CEN-268, REVISION 1  
SUPPLEMENT 1-NP, REVISION 1-NP

**RESPONSE TO NRC REQUEST  
FOR ADDITIONAL INFORMATION  
ON CEN-268**

PREPARED FOR THE C-E OWNERS GROUP BY  
TRANSIENT METHODS AND LOCA GROUP  
NUCLEAR FUEL ENGINEERING

MAY 1987

FIGURE 14  
2700 MW<sub>T</sub> PLANT ANALYSIS  
0.1 FT<sup>2</sup> HOT LEG BREAK  
STEAM BYPASS SYSTEM OPERATIONAL  
SG SECONDARY SIDE PRESSURE

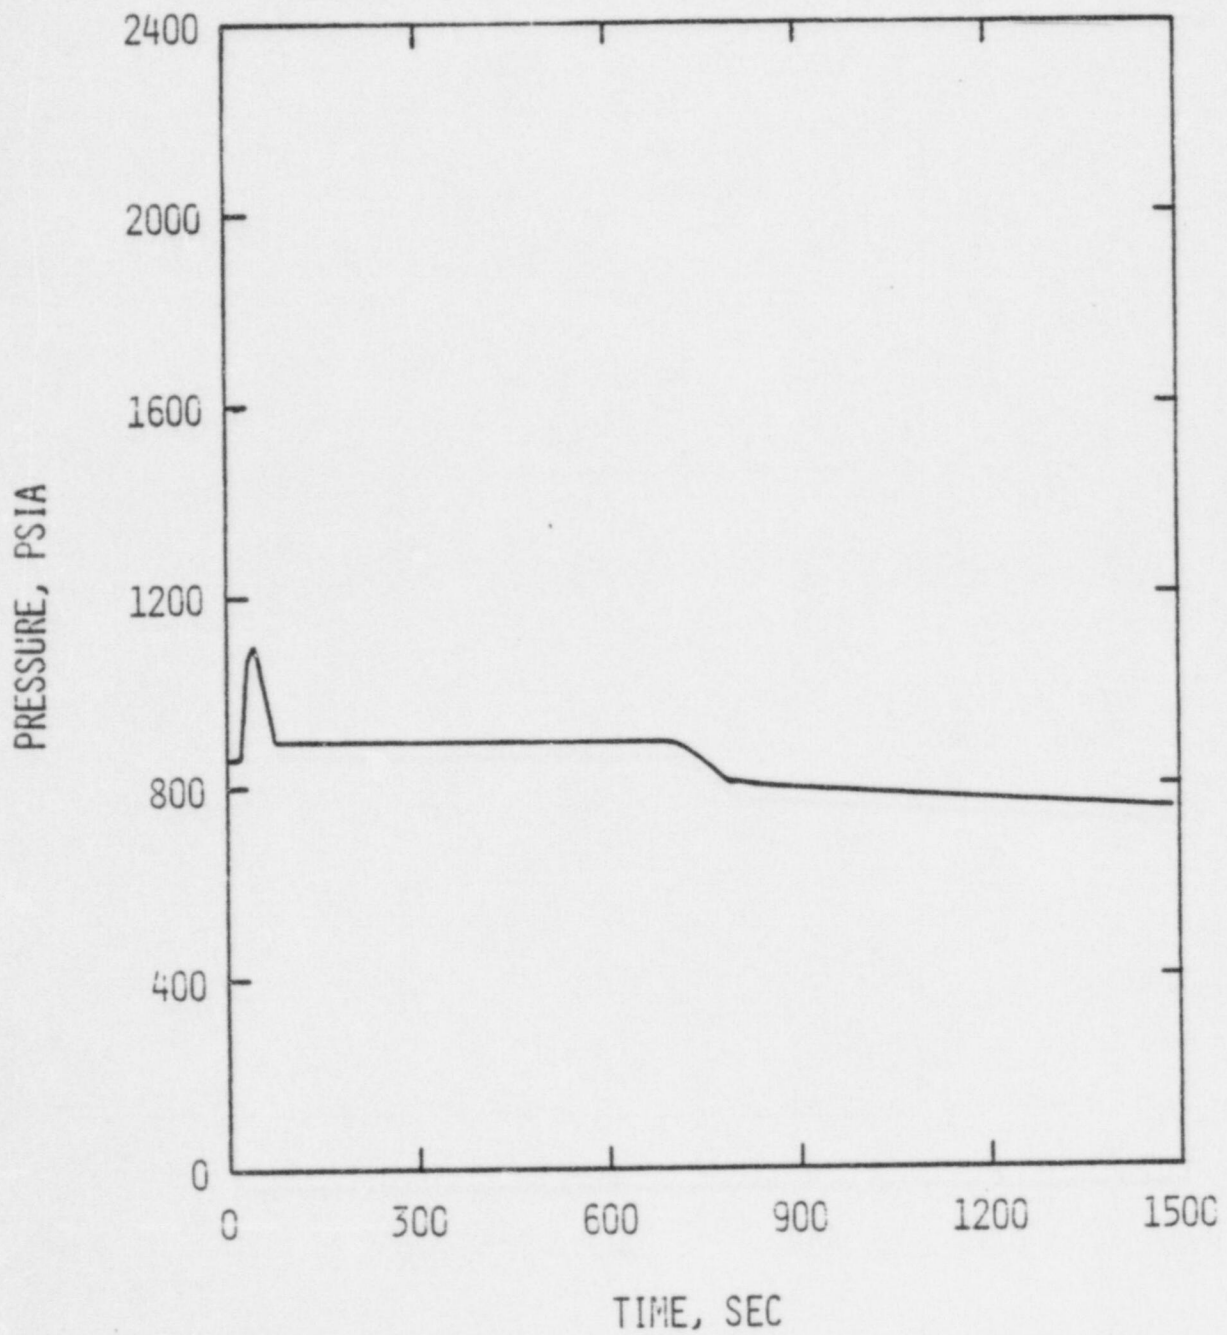
Question 59: We will be performing independent, confirmatory audit analyses of selected transients. In order to benchmark our calculation, please provide the following plots for the 2700 MWt reference plant, for the 0.1 ft<sup>2</sup> hot leg SBLOCA and for the DEGB SGTR cases (where noted by (\*), these data were provided for the SBLOCA in the submittal):

| <u>Parameter</u>                                | <u>Comment</u>            |
|---|---------------------------|
| 1. Secondary side pressure                      | Figure 14, Note 1         |
